BAR Meeting
March 4, 2015

ISSUE: Permit to Demolish/Capsulate and New Construction

LOCATION: 700-710 North Washington Street

BAR2015-00026 & BAR2015-00027

EXTERIOR
ELEVATIONS

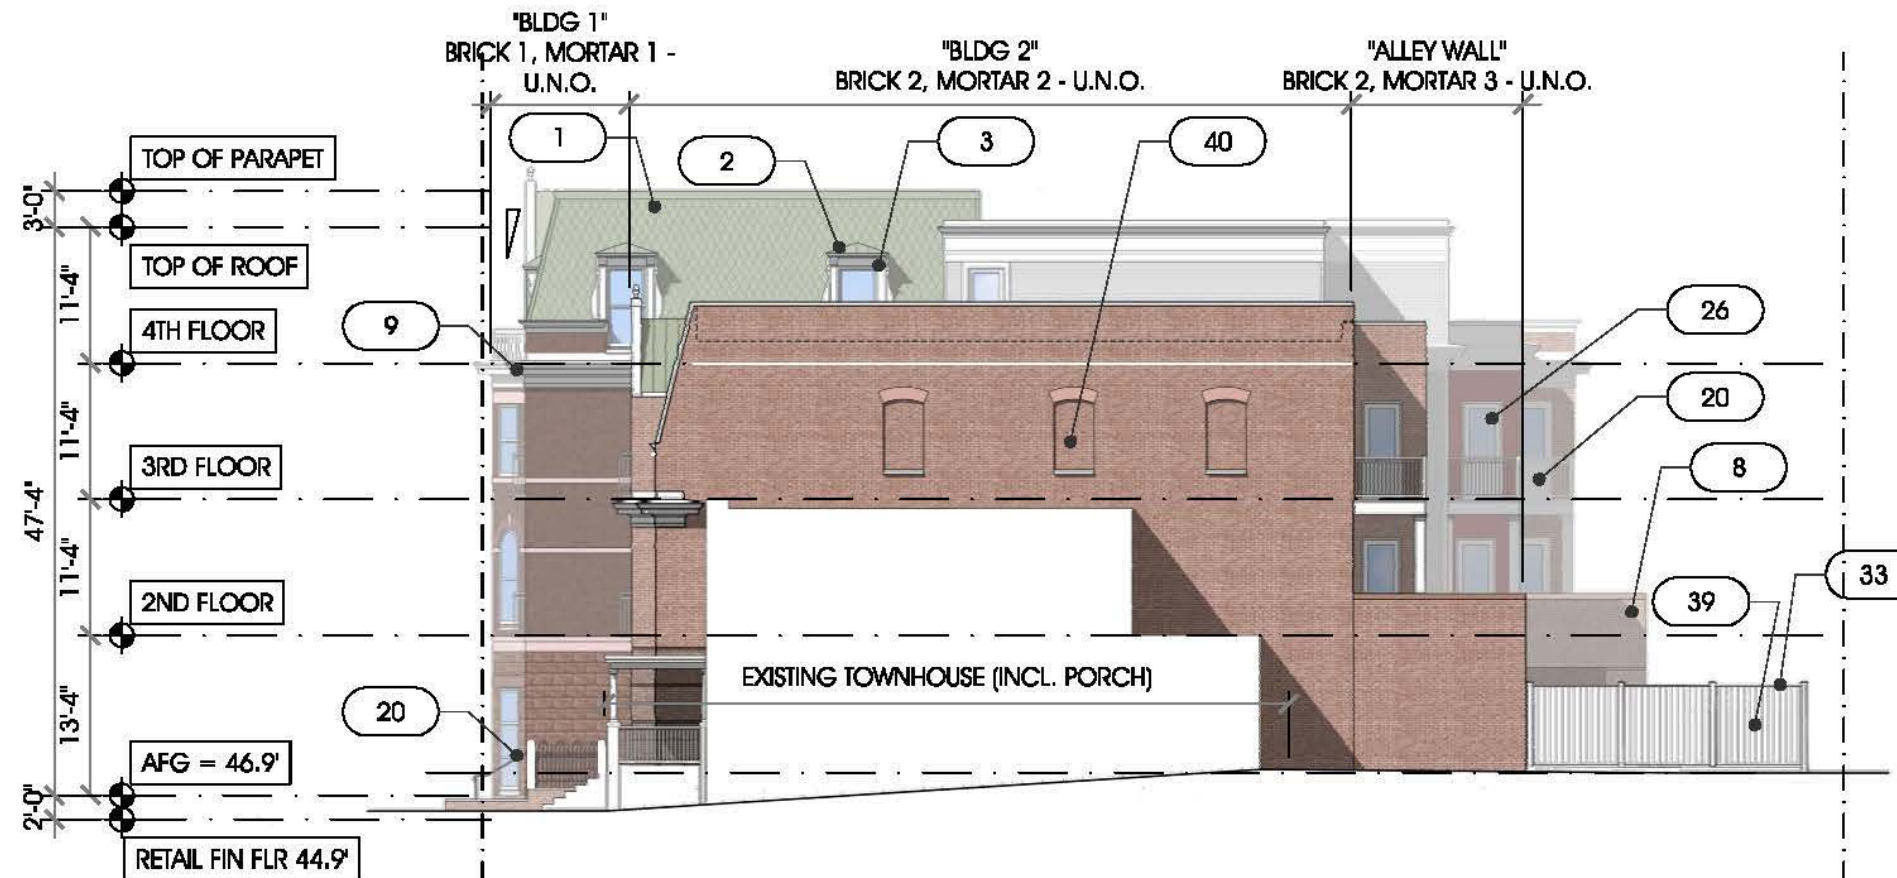
1. Pursue the two story tall bow window alternative shown in the Wythe Street elevation drawings dated February 2, 2015, with a projection of approximately 36" from the building wall. The applicant must acquire approval of an Encroachment from City Council for the bow window before approval of a building permit or must redesign an alternate scheme that does not encroach and return to the BAR for final approval of this elevation.

The concept proposal and current proposal include a pronounced two-story rounded projecting bay, or bow window, onto Wythe Street that is the central design feature of this facade. The depth of the window projection was not specified in the concept review drawings and projections into the City right-of-way are limited to 10" in the City Code. The bay is well-proportioned and a prominent visual feature on this elevation which will also be highly visible from Washington Street. Staff does not believe 10" is adequate and recommends that the BAR require this projection to be increased. Historic bays such as this would typically extend approximately three feet from the building face (see Figures 3 & 4 below). Construction of the bay at the recommended three foot projection will require approval of an encroachment by Planning Commission and City Council.

The applicant has submitted an alternative elevation design for Wythe Street, dated February 26, 2015, that stays within the 10" projection limitation of the Code. However, staff believes this simplified alternative lacks the strong focus of the original design and does not recommend its approval.

WYTHE STREET ROOF EQUIP SIGHT LINES

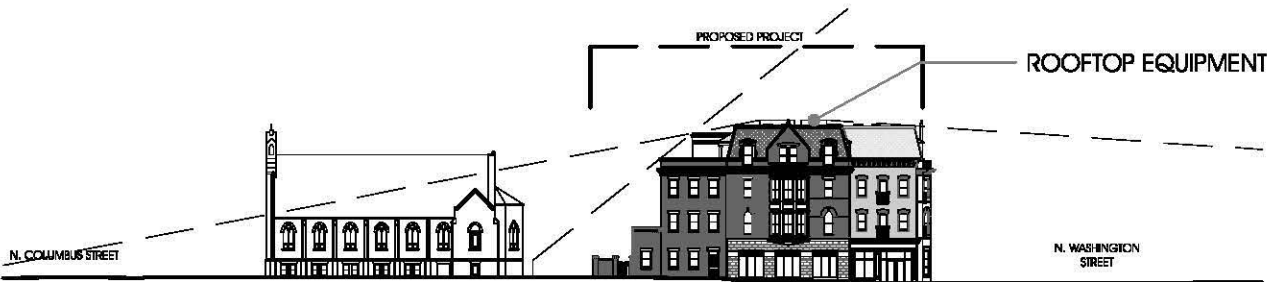
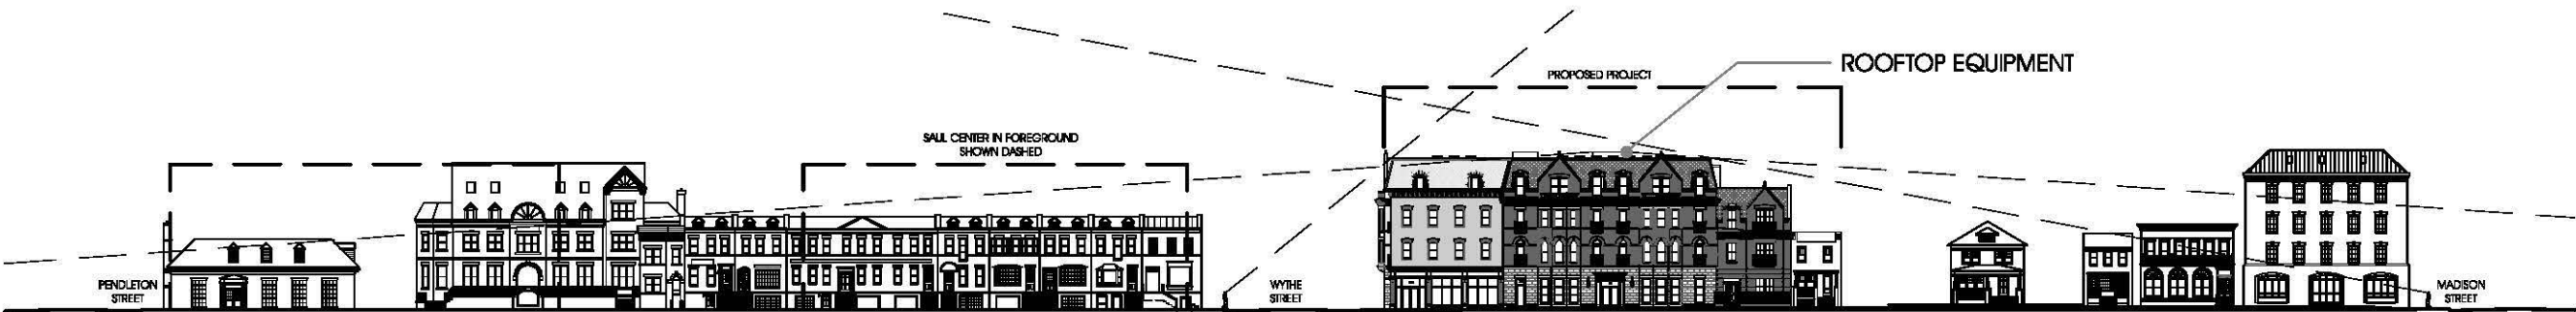
The applicant has provided sight lines showing that the proposed rooftop equipment will be minimally visible. The proposed rooftop equipment will be located near the center of the roof and there will be a parapet for much of the roof. Therefore, staff supports the request for a waiver of rooftop mechanical screening with final unit locations to be confirmed by staff on construction drawings and in the field.
